independent Claim 1 and claims dependent therefrom. The Examiner has pointed out that claims are unrelated if the subject matter has not been disclosed as capable of use together. However, the specification of the present application discloses that the process for spinning the partially oriented yarn and the process for draw-texturing the yarn are related, in that the yarn made in the spinning process is suitable for further use in the texturing process. In particular, on page 6, lines 8 through 11, the specification states that "only partially oriented poly(trimethylene terephthalate) yarns having an [elongation to break] of at least 110%, and which are made from polymer having an IV of at least 0.70 dl/g are stable and can be successfully draw-textured according to the process of the present invention". Moreover, a partially oriented poly(trimethylene terephthalate) yarn is required for the texturing process recited in Claim 3. Accordingly, Applicants respectfully submit that the two processes are related and the restriction is respectfully traversed.

CLEAN UNMARKED VERSION

FIG. 3

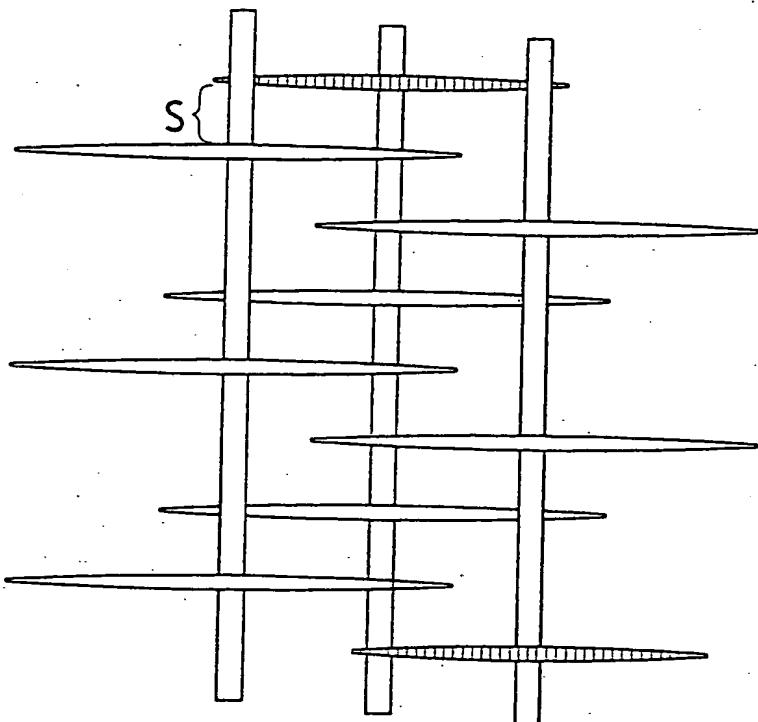
The caption of Figure 3 has been amended, as requested by the Examiner, to indicate that the figure illustrates the prior art. A replacement page for the page on which Figures 3 and 4 originally appeared is attached.

Prior art
